UNITED STATES PATENT AND TRADEMARK OFFICE

APPLICATION NO.	FILING DATE	FIRST NAMED INVENTOR	ATTORNEY DOCKET NO.	CONFIRMATION NO.
09/989,271	11/20/2001	Michael C. Smyk	FCI-2632/C3069	9590

Office Action Summary	Application No. 09/989,271	Applicant(s) SMYK, MICHAEL C.	
	Examiner James R. Harvey	Art Unit 2833

DETAILED ACTION

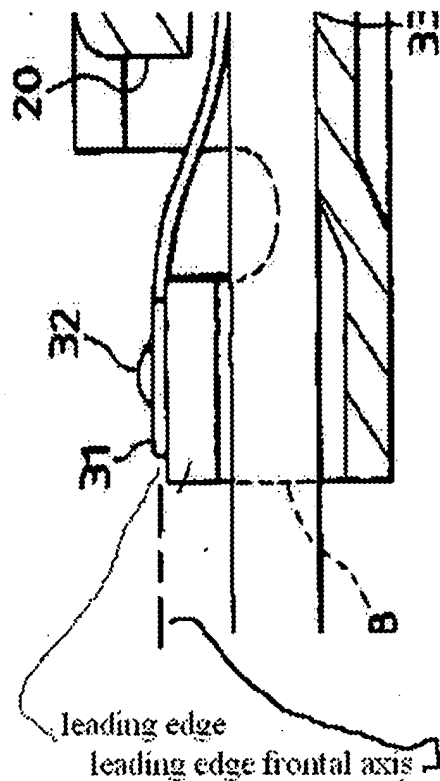
-- In reference to Claim(s) 45, FP 850' shows (figure 3)

a contact section for mating with a complementary male terminal, the contact section including a bottom wall 13;

a first set of sidewalls 18 that define a first tubular portion with the bottom wall; and a second set of sidewalls 14, which are longer than the first set of sidewalls, that define a second tubular portion with the bottom wall, the second tubular portion arranged end to end with the first tubular portion; and

a flexible contact element 10 at least partially disposed within the contact section in a non-fixedly secured manner (column 5, lines 33-37) for urging a complementary male terminal into engagement with the bottom wall.

-- In reference to Claim(s) 47, FP 850' shows (cover sheet) the flexible contact element includes a leading edge (see examiner's figure), and wherein the female electrical terminal is devoid of any structure prohibiting frontal access to the flexible contact element leading edge (see examiner's figure).

-- In reference to Claim(s) 50 and 53, FP 850' shows (cover sheet) the flexible contact element includes a leading edge (see examiner's figure), and wherein the female electrical terminal is devoid of any structure prohibiting frontal access to the flexible contact element leading edge.
